# Notes for Users

This supplement provides notes and corrections for the manuals provided with this machine. Read this supplement in conjunction with the relevant manual.

BZH047

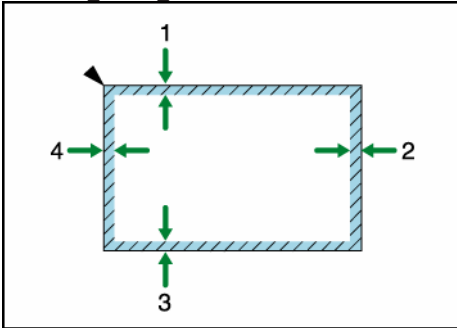
"Missing Image Area" in 1. Placing Originals in *Operating Instructions Copy and Document Server Reference*

### Missing Image Area

2. **0.5 - 6.0 mm (0.02 - 0.24 inch) (3.0 - 6.0 mm (0.12 - 0.24 inches) in Duplex mode)**
